CITY OF MOBILE
TIGER 2016 Project Phase Four- Dr. Martin Luther King Jr. Ave from NW of Butchers
Lane to Beauregard St
Project No. 2023-2045-01

ADDENDUM #2

This addendum includes the following: (1) revised contract language, (2) revised PROPOSAL form (Attachment "A"), (3) responses to remaining questions and (4) updated plan sheets (Attachment "C"). This addendum consists of a total of 93 pages, including the cover page.

SUMMARY OF PLAN SHEET CHANGES

REFERENCE PROJECT NO	FISCAL YEAR	SHEET NO
2023-2045-01 TIGER-FAUP-4917(250)	2025	412

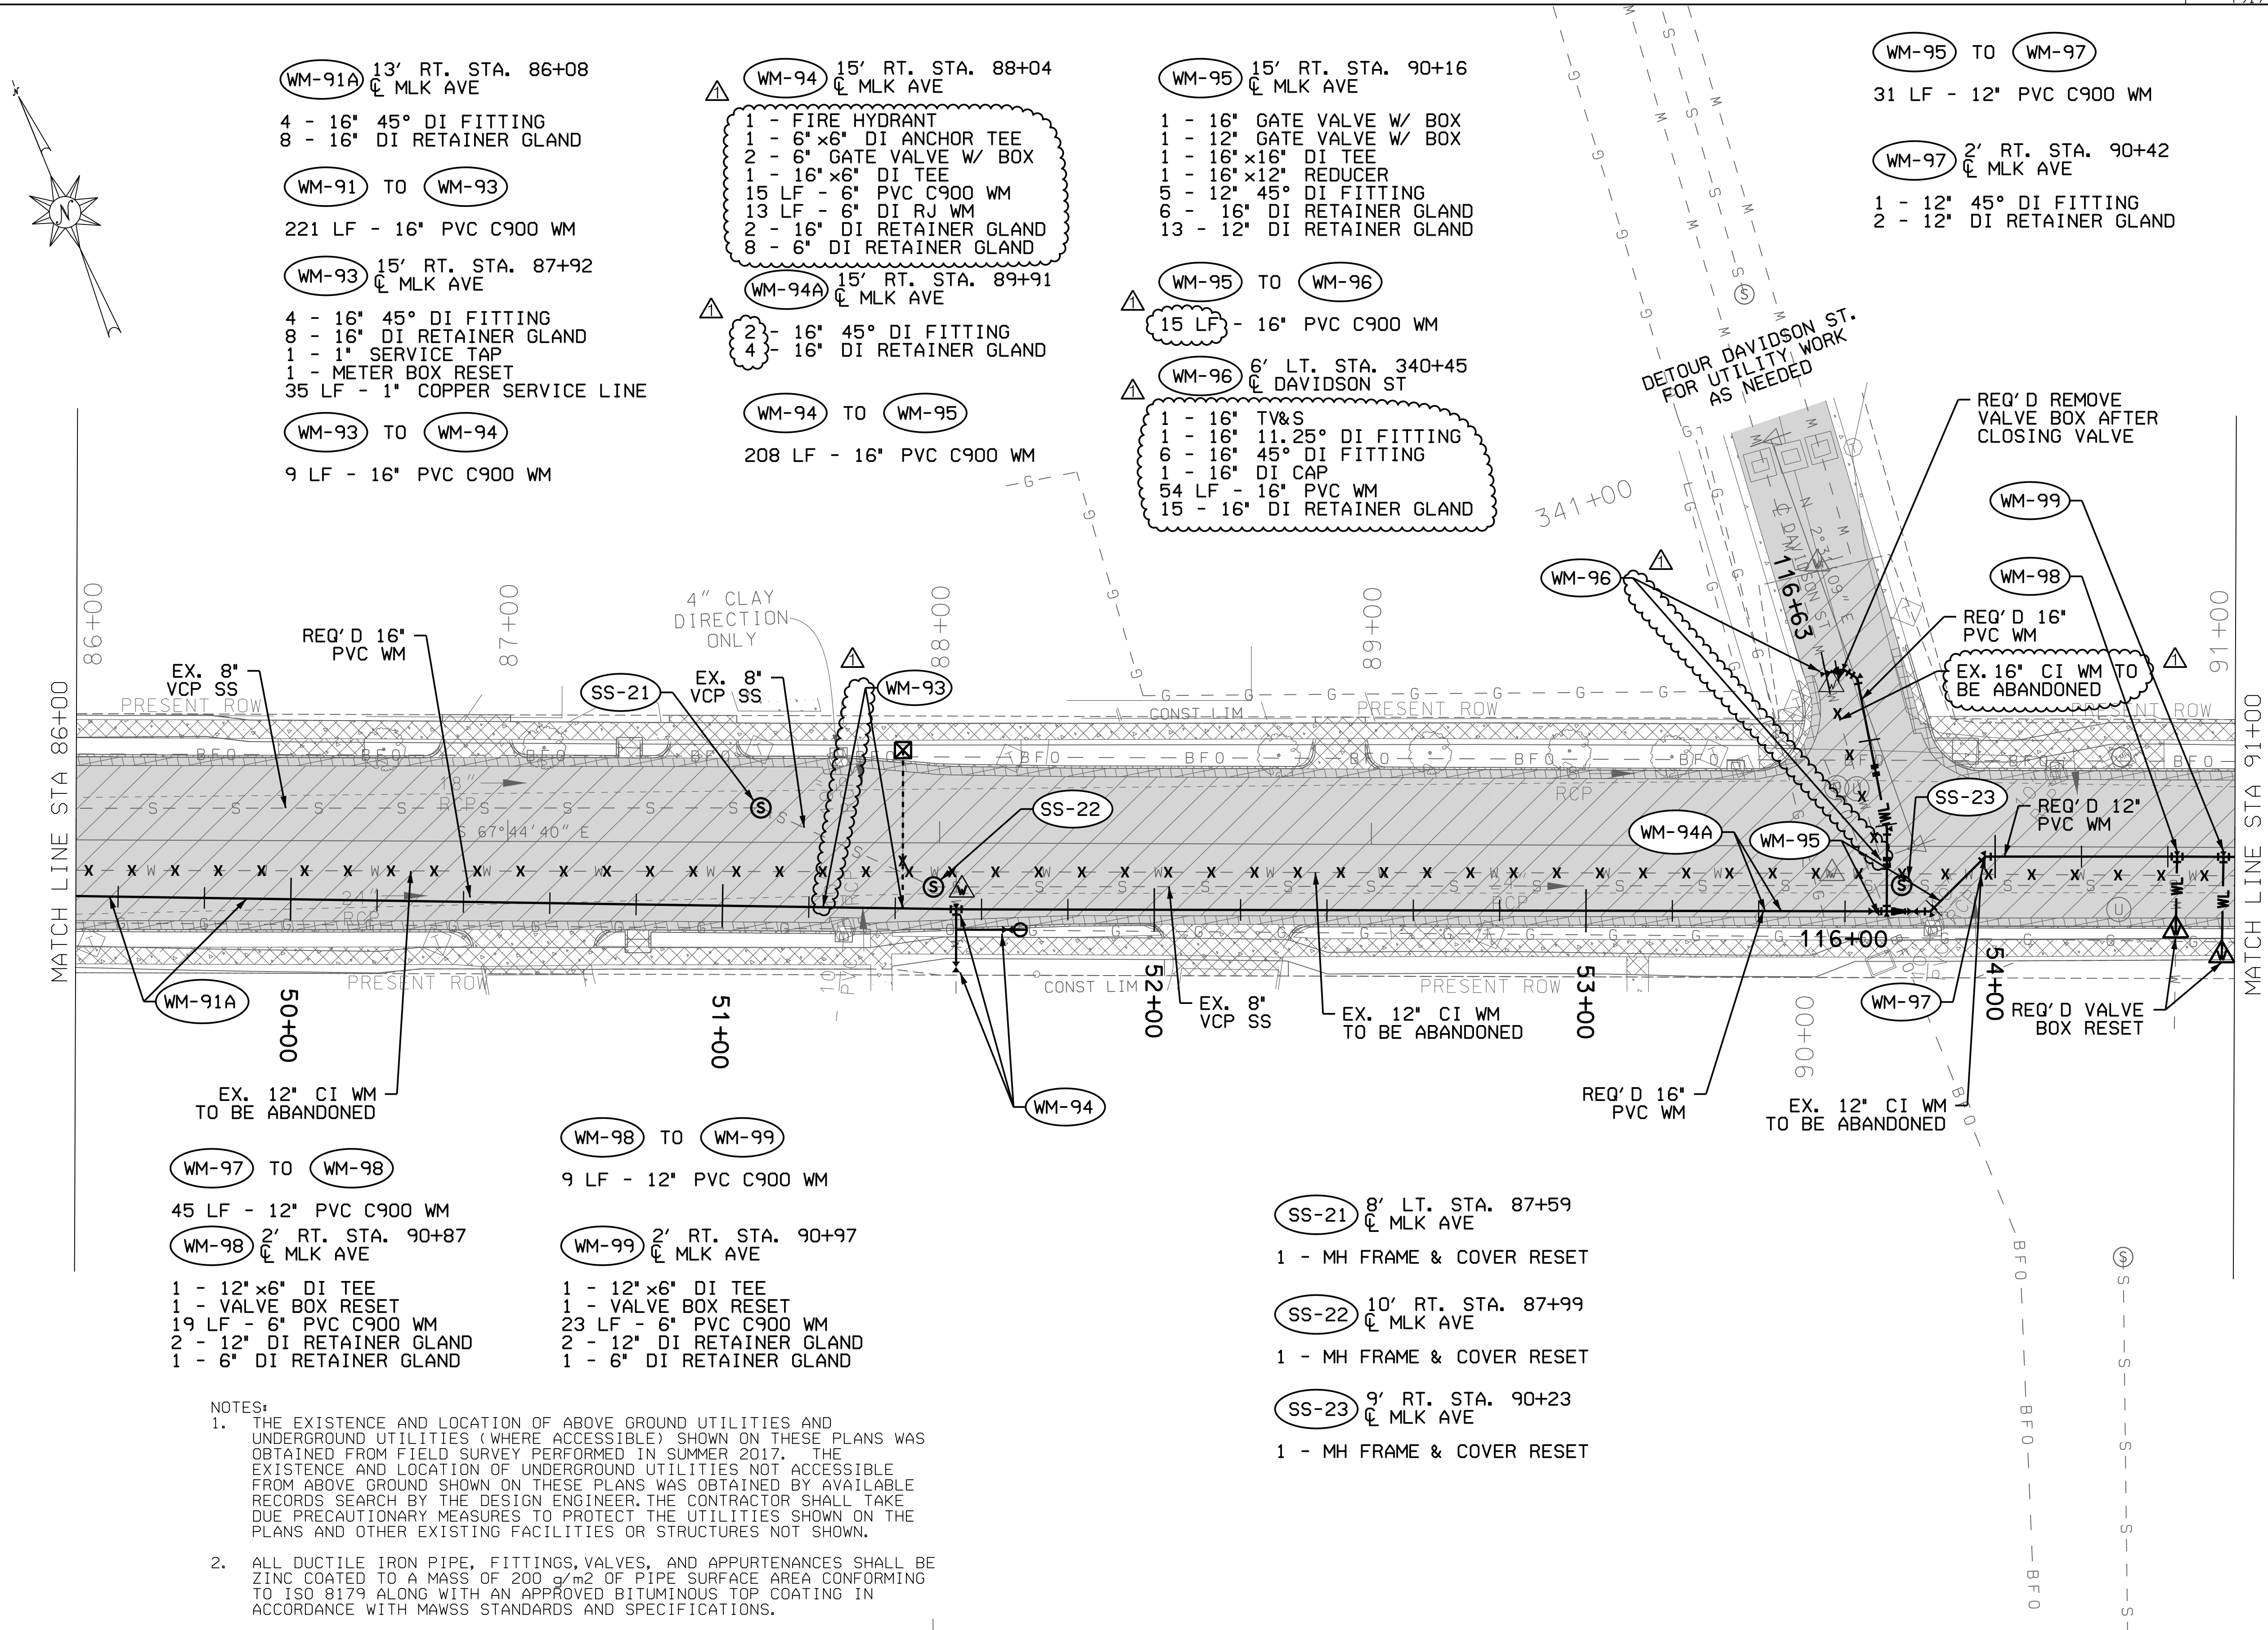
- 3 – 6” DI Retainer Glands
- **SHEET 411A**
 - Added symbology and Callout **WM-90B** to profile
- **SHEET 412**
 - Callout WM-93 and WM-96 – Modified leader arrows

- Callout WM-94 – Revised pipe length and retainer gland quantities
 - Callout WM-94A – Revised 45° fittings and retainer gland quantities
 - Callout WM-95 to WM-96 – Revised pipe length quantity

- Callout WM-96 – Revised 45° fittings and retainer gland quantities
 - Added “To be abandoned” to “Ex. 16” CI WM” text below callout WM-98
- **SHEET 412A**

REFERENCE PROJECT NO	FISCAL YEAR	SHEET NO
2023-2045-01 TIGER-FAUP-4917(250)	2025	412A

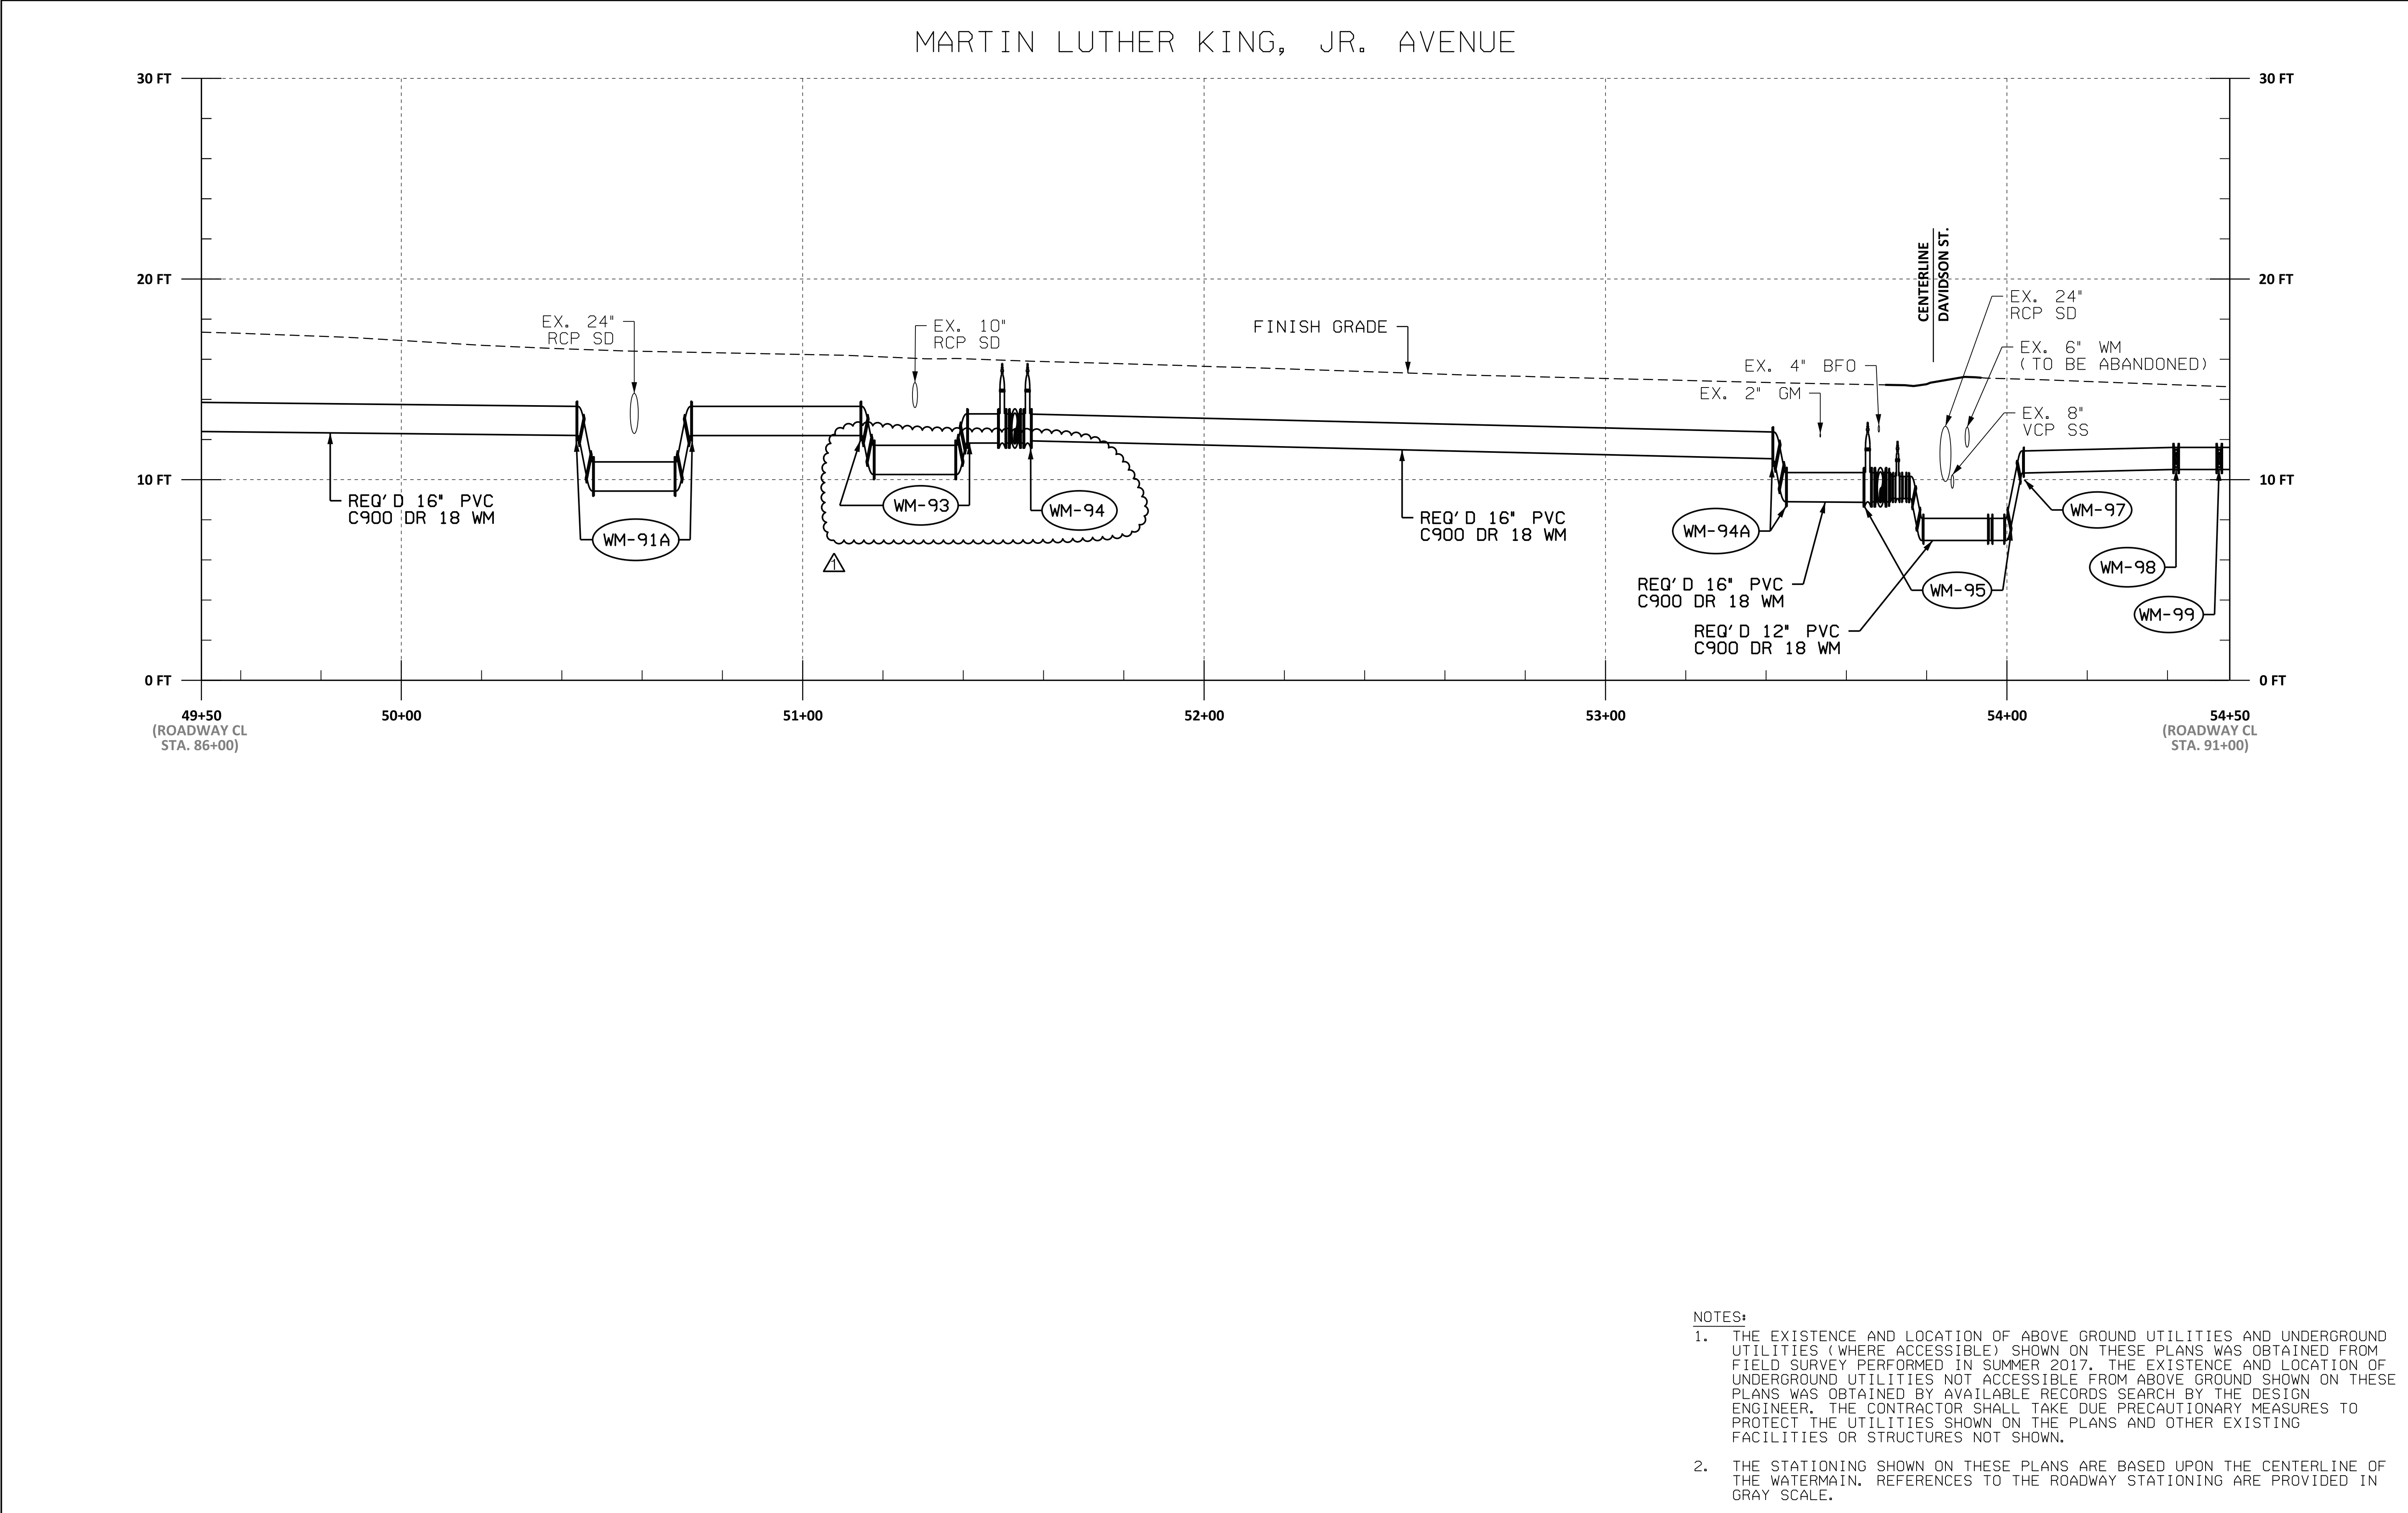
- Callouts WM-93 and WM-94 – Modified leader arrows
- **SHEET 412B**
 - Callouts WM-95 and WM-96 – Modified leader arrows

REFERENCE PROJECT NO	FISCAL YEAR	SHEET NO
2023-2045-01 TIGER-FAUP-4917(250)	2025	413

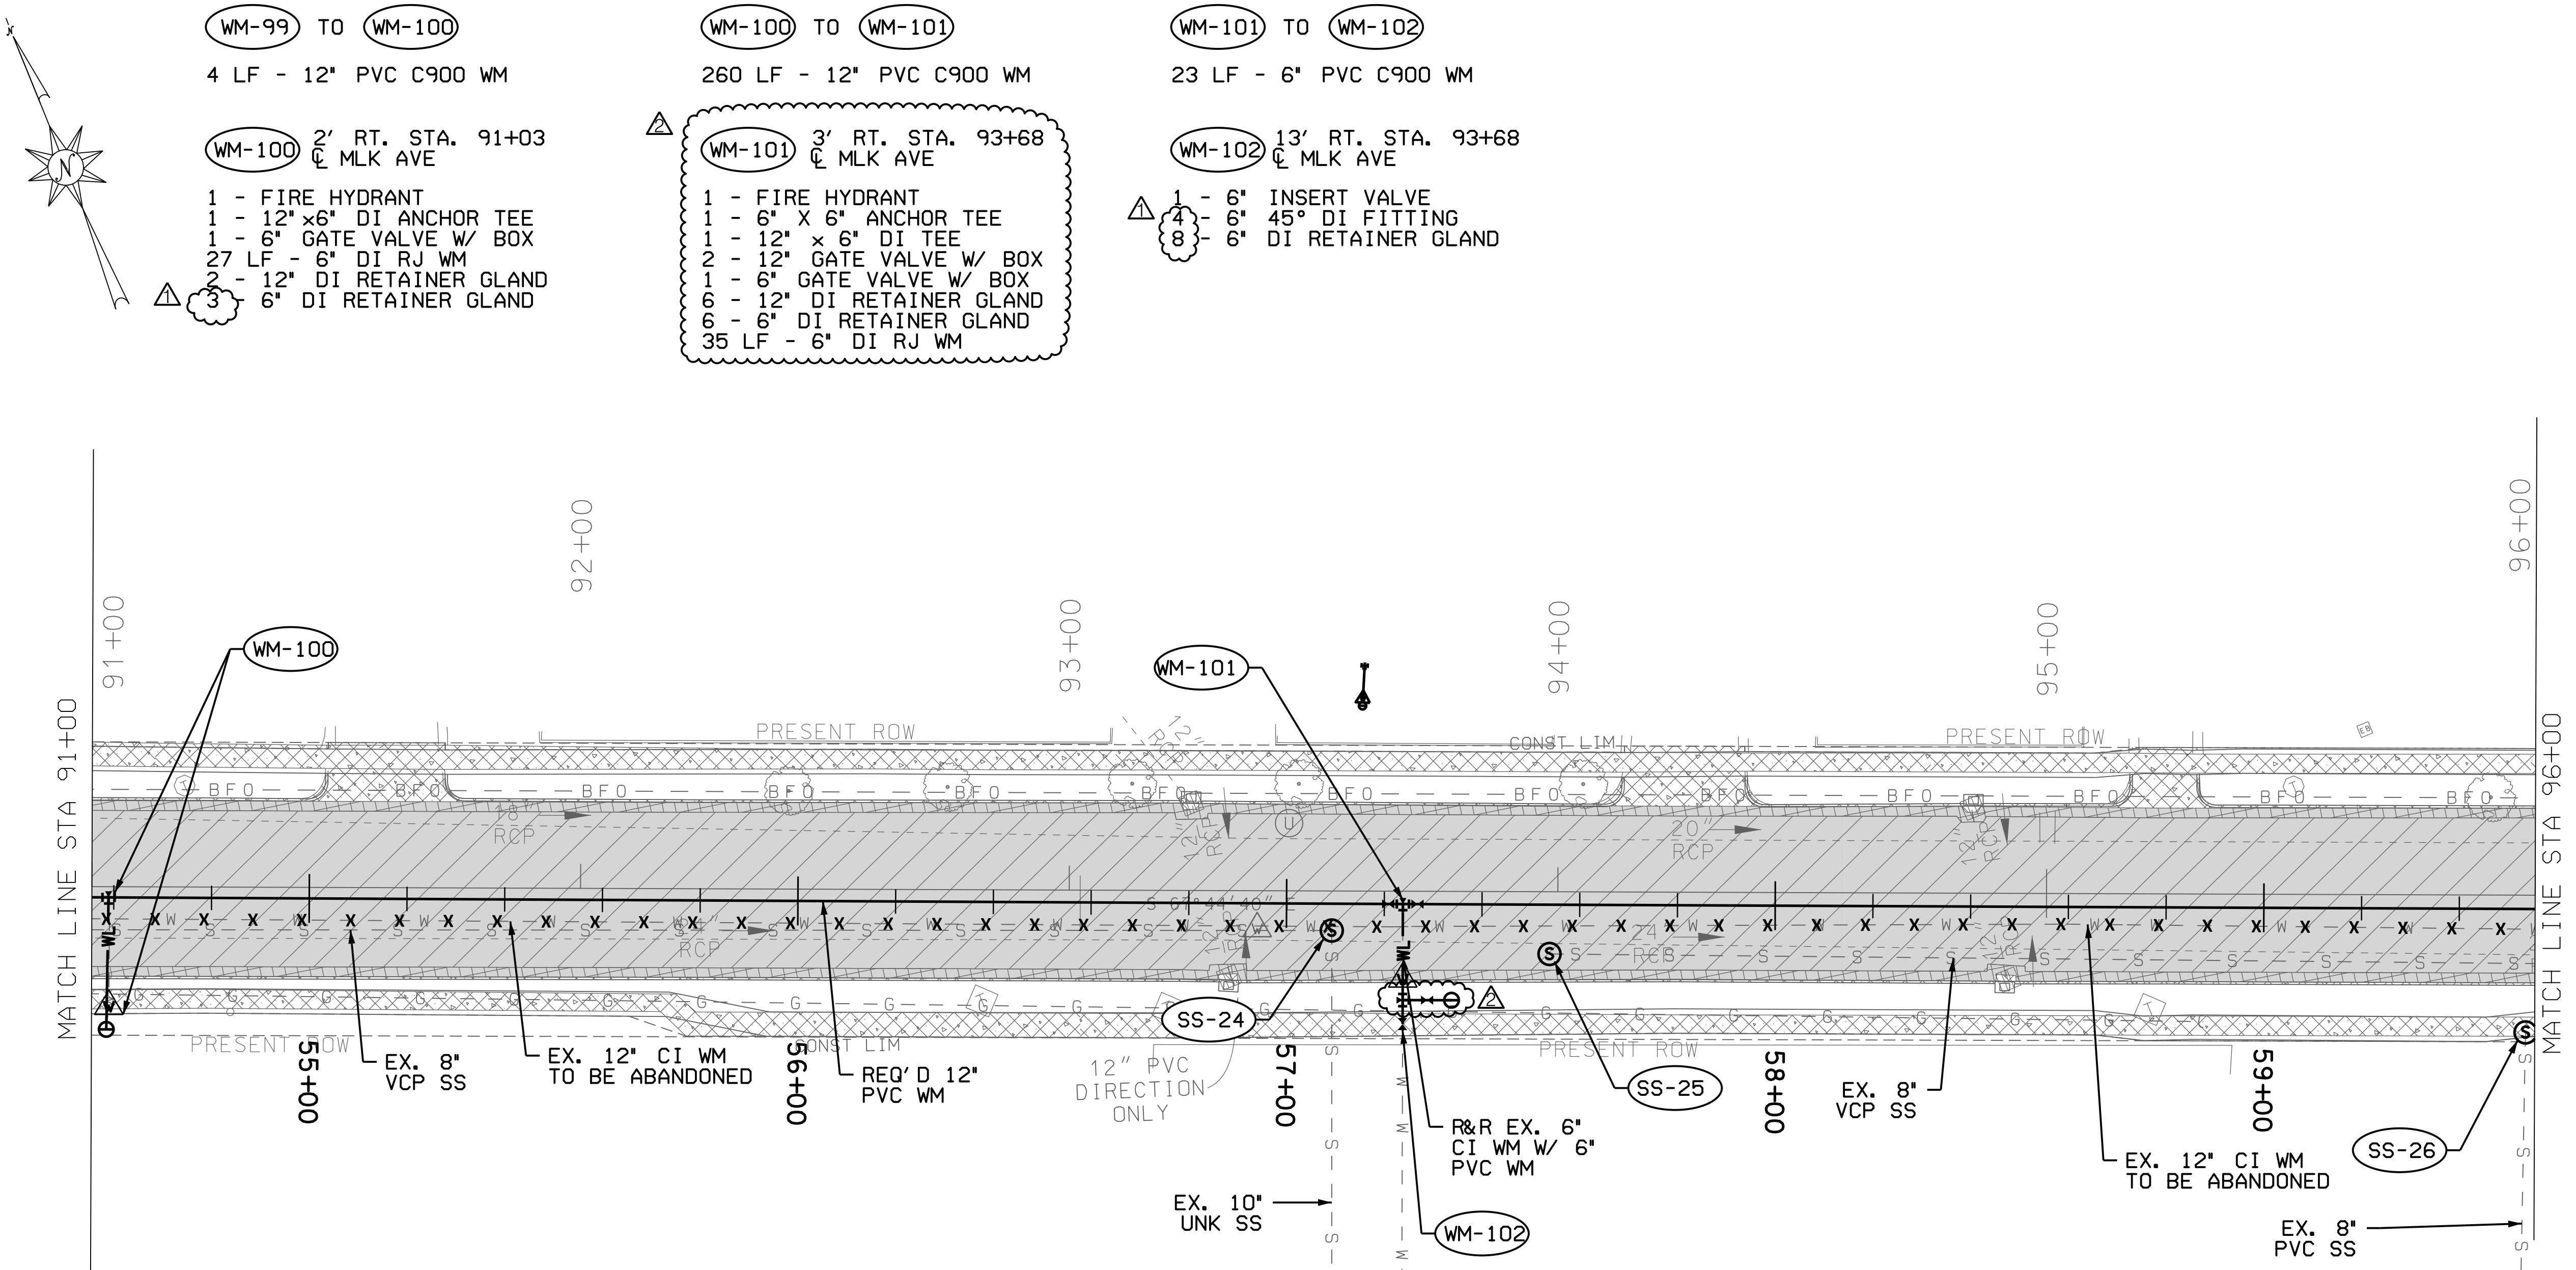
- **SHEET 413**
 - Callout WM-100 – Revised 6" retainer gland quantity
 - Callout WM-102 – Revised 45° fitting and retainer gland quantities
 - Modified description Callout **WM-101** to include the following:

- 1 – Fire Hydrant
 - 1 – 6"X6" DI Anchor Tee
 - 1 – 6" Gate Valve W/ Box
 - 10 LF – 6" DI RJ WM
 - 5 – 6" DI Retainer Glands
- **SHEET 414**
 - Callout WM-103 – Modified 12"x3" tee to 12"x4" tee and revised copper service line length
